Explanation of Significant Differences

**Ten-Mile Drain Superfund Site
St. Clair Shores, Michigan**

September 2016

Figure 3. Manhole Vault Structures and RCP beneath Harper Avenue

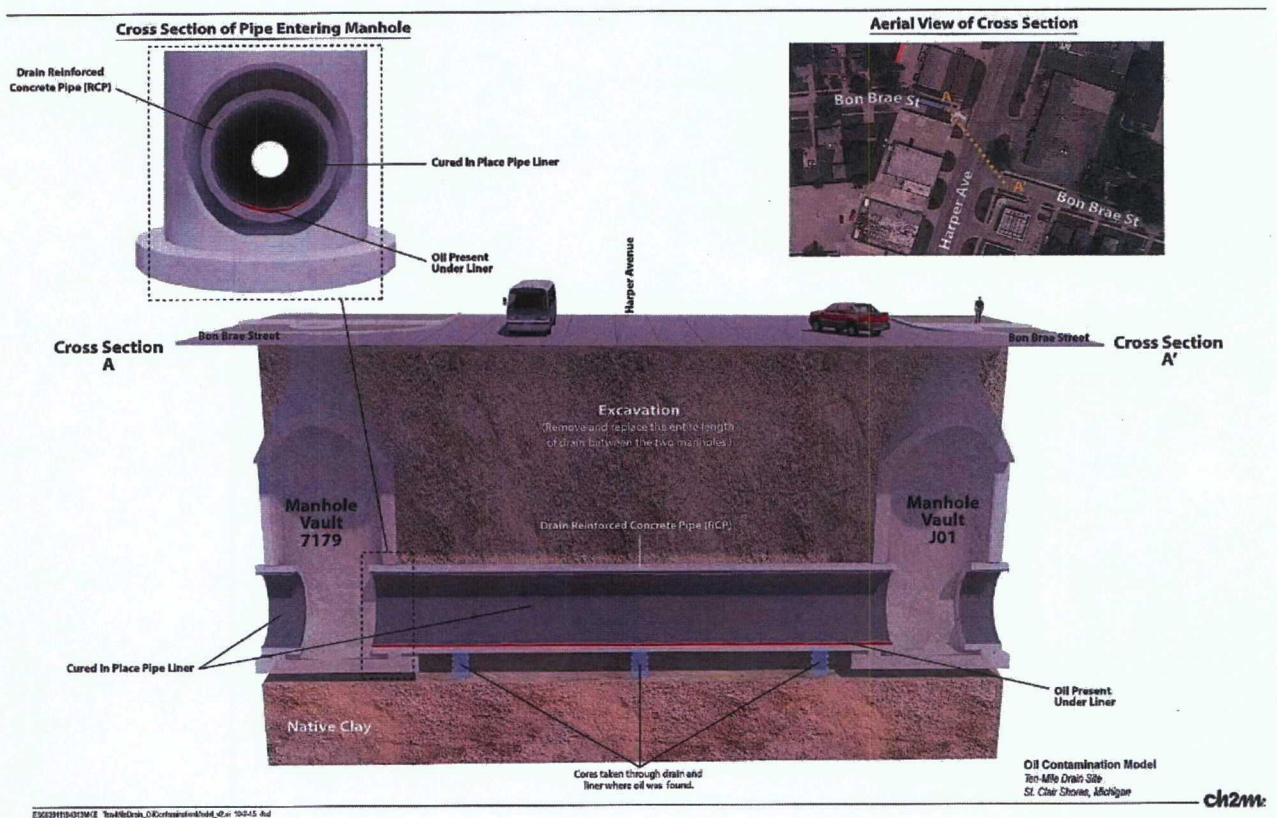
The 2014 interim ROD selected the removal and replacement of two vaulted manhole structures – M7179 and J01 – in the TMD storm sewer system along with PCB-contaminated bedding and backfill materials. During the excavation of the M7179 manhole vault, PCB-containing oil was observed flowing from between the cured-in-place pipe (CIPP) liner and the 48-inch-diameter reinforced concrete pipe (RCP) that

extends under Harper Avenue (see Figure 3). Based on this new development, and to prevent recontamination of areas that had just been cleaned up, EPA expanded the interim action to include removal and replacement of the 120-foot length of RCP between manhole vaults M7179 and J01, along with the bedding materials surrounding the pipe. The excavation of the RCP led to several other modifications to the remedy components described in the 2014 interim ROD.

This ESD discusses the following four modifications to the selected remedy: (1) the excavation and replacement of the 120-foot length of RCP and impacted bedding materials beneath Harper Avenue between manhole vaults M7179 and J01; (2) the use of an alternate manhole vault lining method; (3) installation of two anti-seep collars; and (4) a reduction in the number of extraction and monitoring wells. In addition, this ESD also documents the use of an onsite carbon filtration system to treat water pumped from the open excavation before discharging it back to the storm drain. This was required due to heavy rainfall during construction that resulted in a large quantity of PCB-contaminated water exceeding Toxic Substances Control Act (TSCA) levels. While the onsite carbon treatment system was not listed as a major element of the selected interim remedy, the quantity of water that required treatment and the associated cost increase is worthy of documentation in this ESD.

Figure 4. Cross Section of Pipe entering Manhole

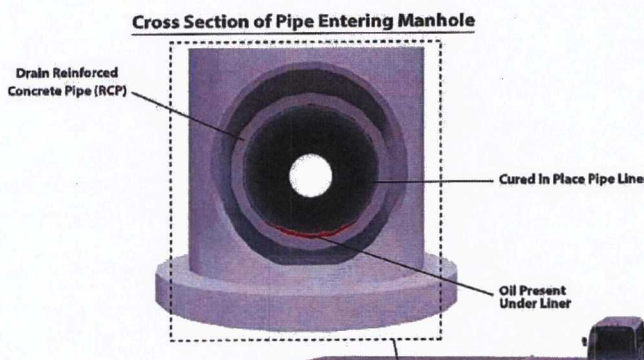
EPA started the construction work to remove the two manhole vault structures in early June 2015. During the excavation of manhole M7179, oil (which was confirmed to be PCB oil) was observed between the CIPP liner and the RCP (see Figure 4).

EPA contractors cut back the CIPP liner that was installed inside the RCP during the 2006 removal action, and oil began to flow out of the end of the pipe into the M7179 open excavation (see Figure 5).

Borings collected through the liner and RCP confirmed the presence of PCBs, with the highest sample result being 78,700 ppm. This new information obtained during implementation of the remedial action led EPA to expand the project and remove the 120-foot length of pipe between the two manhole vaults, along with impacted bedding materials. EPA determined that the expansion of the project was necessary and consistent with the intent of the 2014 interim ROD. Information supporting this change is included in Supplement 8 to the administrative record (see attachment).

and the Lange and Revere Street canals. As discussed earlier in this ESD, PCB oil flowed into the open excavation from between the liner and pipe during the excavation of manhole vault M7179. This prompted EPA to expand the interim remedial action to include the removal and replacement of the 120-foot length of RCP running between the two manhole vaults, along with the underlying materials. The expanded remedial action is consistent with the remedial action objectives in the 2014 ROD and necessary to prevent further PCB migration to the Lange and Revere Street canals and further environmental degradation.
